THE BRIDGES

ADDENDUM TO ARCHITECTURAL DESIGN & CONTROL GUIDELINES (Formerly Bow Valley Centre Lands Redevelopment)

22 June 2005

Addition to Illustration 8 : Building Orientation and Design

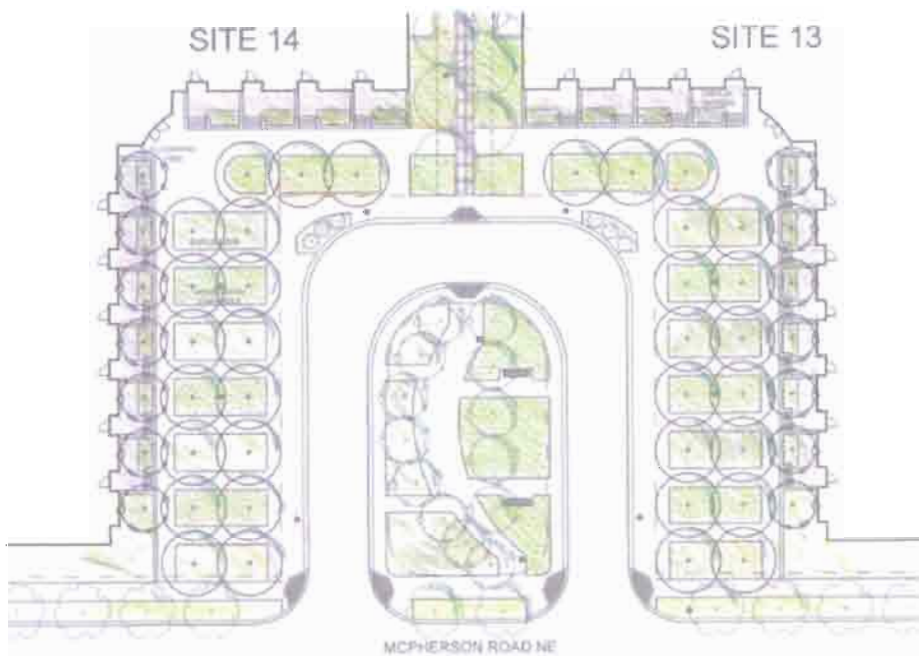
This photo illustrates front doors: addressing the street for each main floor unit; including traditional entrance elements like the hinged front door, a door bell and house numerals.

Guidelines - The front doors for each main floor dwelling unit, (those that front onto a public street or public thoroughfare), shall be designed and constructed to serve as the primary dwelling unit entrance.

Discussion - These front doors must open into appropriate 'public' rooms within the dwelling unit: living room or dining room. These front doors shall not open into inappropriate 'private' rooms within the dwelling unit: bedroom, den, storage, or the like.

Guidelines - The primary dwelling unit entrance (front door), for all main floor dwelling units is to be the location at which visitors are greeted; Canada Post, newspapers, and couriers deliver; door-to-door canvassing occurs; fast food is delivered; and the like.

Discussion - Although the actual residents are likely to access their main floor dwelling unit through an internal corridor, via below grade parking, through an internal elevator, this 'internal' access door should not be designed and constructed as the 'front door'.

Guidelines - The primary dwelling unit entrance (front door), for all main floor dwelling units should include traditional dwelling unit entrance elements such as: a hinged front door, a door bell, house address numerals, and an exterior light fixture.

Discussion - The primary dwelling unit entrance should not be a sliding door. In our culture, sliding doors are not used for front doors.

Discussion - The primary dwelling unit entrance may also include other entrance elements that have become familiar, such as a drop box (mail box), and the like.
